COMMENTS AND RESPONSES: DRAFT SCOPING REPORT FOR THE PROPOSED SUNVELD SOLAR PV AND BATTERY ENERGY STORAGE (BESS) FACILITY ON FARM KRUISPAD 120 AND ON THE FARM DOORNFONTEIN A 118 SITUATED APPROXIMATELY 7.5 KM EAST VELDDRIF IN THE BERG RIVER MUNICIPALITY OF THE WESTERN CAPE PROVINCE.

DFFE Reference Number: 14/12/16/3/3/2/2436

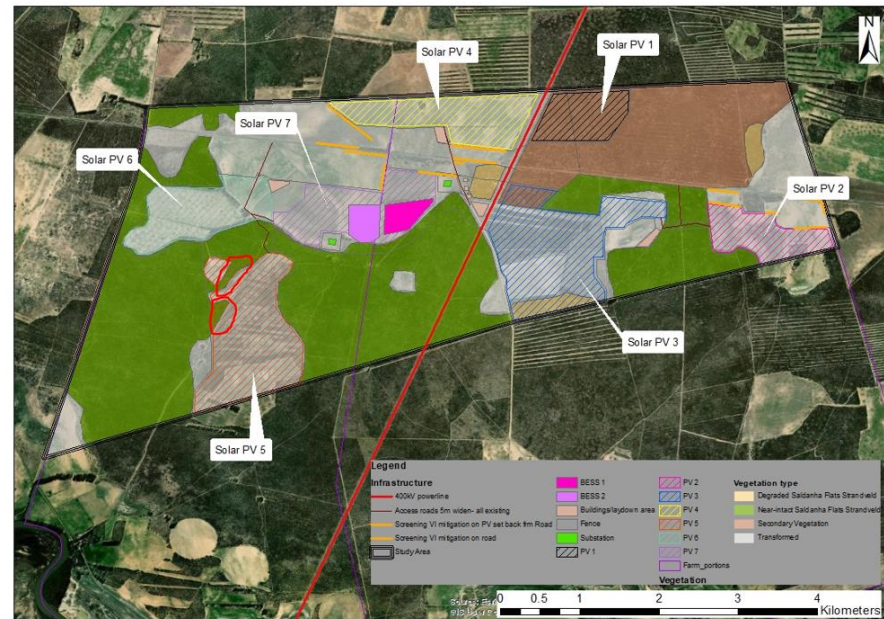
Comment: Therefore there is a great loss in Saldanha Flat Strandveld, secondary vegetation and loss of plant species of conservation concern due to large extent of indigenous vegetation clearance. How will this be mitigated?

This section in draft BAR related to a discussion on the botanical component of the entire study site which included that affected by the development footprint as well as areas that were avoided due to their sensitivity.

The footprint of the development was however designed in such a way as to avoid all of the near intact Saldanha Flats Strandveld with the exception of a small fragmented portions as highlighted in red in the image below.

There is a small area of 9.1ha of near-intact vegetation and 15.8ha of degraded vegetation that will be impacted by project infrastructure which the specialist found this to be of low significance after mitigation. To account for this loss, areas within the study area, that will not be affected by project infrastructure, will need to be rehabilitated (alien vegetation managed) and set aside as conservation areas. The loss of a small subpopulation of *Leucospermum rodolentum* must be mitigated by ensuring that set aside areas include this species and that these subpopulations increase in size over time to account for the loss of the subpopulation to Solar PV 1. This would result in a net gain of Saldanha Flats Strandveld and *Leucospermum rodolentum* over the long
